APPLICATION NO.	FILING DATE	FIRST NAMED INVENTOR	ATTORNEY DOCKET NO.	CONFIRMATION NO.
10/714,265	11/14/2003	Harold A. Ladouceur	60,152-1003	3851

Office Action Summary	Application No. 10/714,265	Applicant(s) LADOUCEUR, HAROLD A.	
	Examiner Jeffrey Sharp	Art Unit 3677

DETAILED ACTION

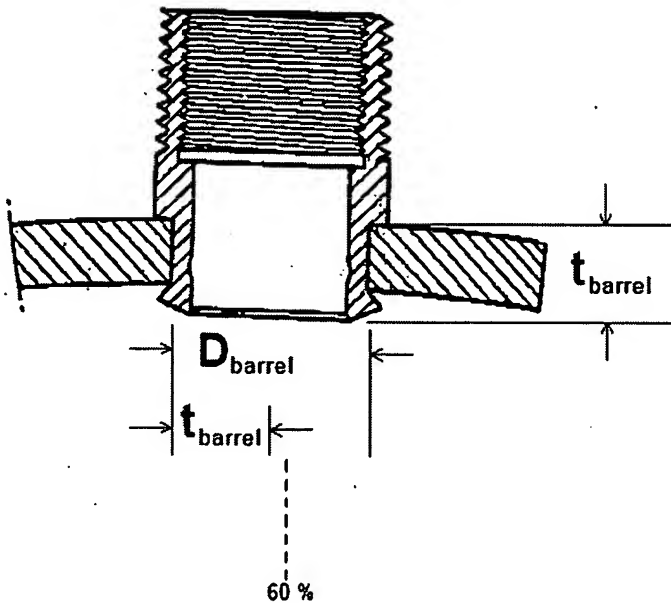
Foster et al. DOES teach each and every limitation found in the instant claim 1, including the specific relative size limitation *"said tubular barrel portion has an axial length equal to or less than sixty percent of an outer diameter of said generally cylindrical outer surface of said tubular barrel portion"* as shown in the figure below:

However, Applicant has amended claim 1 such that the Foster et al. reference fails to anticipate the added relative hardness limitation (greater than Rockwell C 30). Consequently, upon further consideration, a new ground(s) of rejection necessitated by amendment is made below.

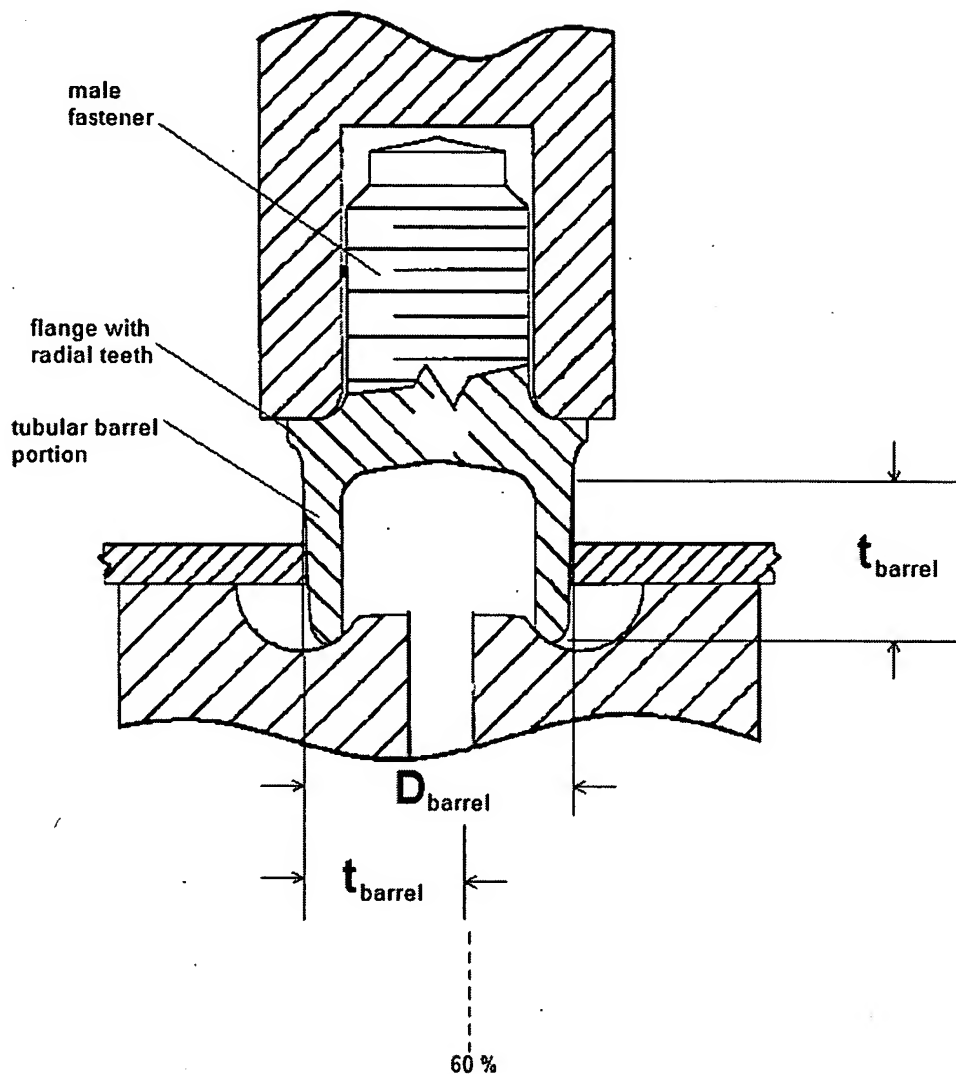
The disclosure set forth in US-5,868,535 would suggest to someone ordinarily skilled, a male fastener having the limitations in claims 1 and 3-21. As for the relative size limitation, Ladouceur (although not expressly in the specification) depicts a male fastener having a *"tubular barrel portion has an axial length equal to or less than sixty percent of an outer diameter of said generally cylindrical outer surface of said tubular barrel portion"*

With regard to Applicant's argument on the bottom of page 12 remarks, that *"the outer surface of the barrel portion [taught by Ladoucer] is not cylindrical"*, Applicant is directed to column 4 line 66 - column 5 line 1 of the '535 patent, which states: *"The tubular riveting portion 22 further includes an internal surface 38 and an external surface 40 which are generally cylindrical."*

Consequently, upon further consideration of the art and full consideration of Applicant's remarks, the rejection of claims 1 and 3-21 under 35 U.S.C. 103(a) as being obvious over Ladouceur US-5,868,535 stands. Claim 2 has been cancelled, and thus all arguments drawn to claim 2 are moot.

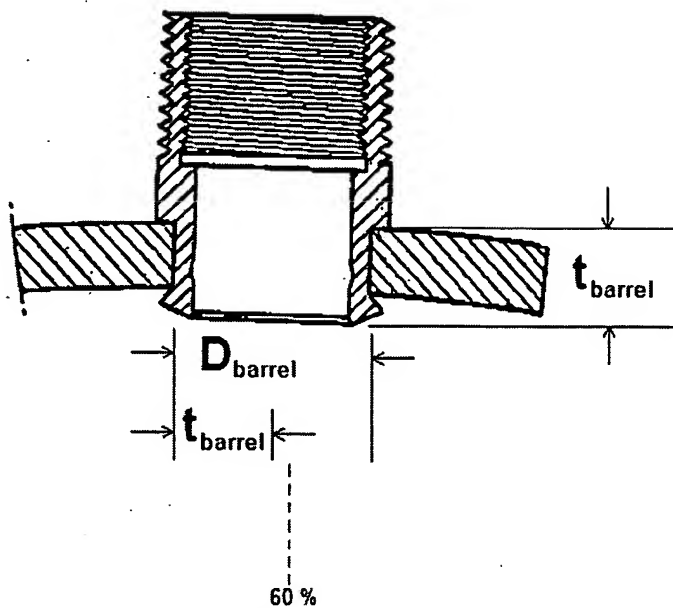
In short, Foster et al. teaches a male self-riveting fastener having a flange and a tubular barrel portion that is radially outwardly deflected. The fastener comprises the specific relative size limitation: *"said tubular barrel portion has an axial length equal to or less than sixty percent of an outer diameter of said generally cylindrical outer surface of said tubular barrel portion"* as shown in the figure below:

However, the Foster et al. reference is silent as to the hardness of the fastener.

At the time of invention it would have been obvious to one having an ordinary skill in the art, to make the fastener taught by Foster et al. greater than 30 Rockwell on the C scale, in order to prevent thread stripping which is common with softer metals.
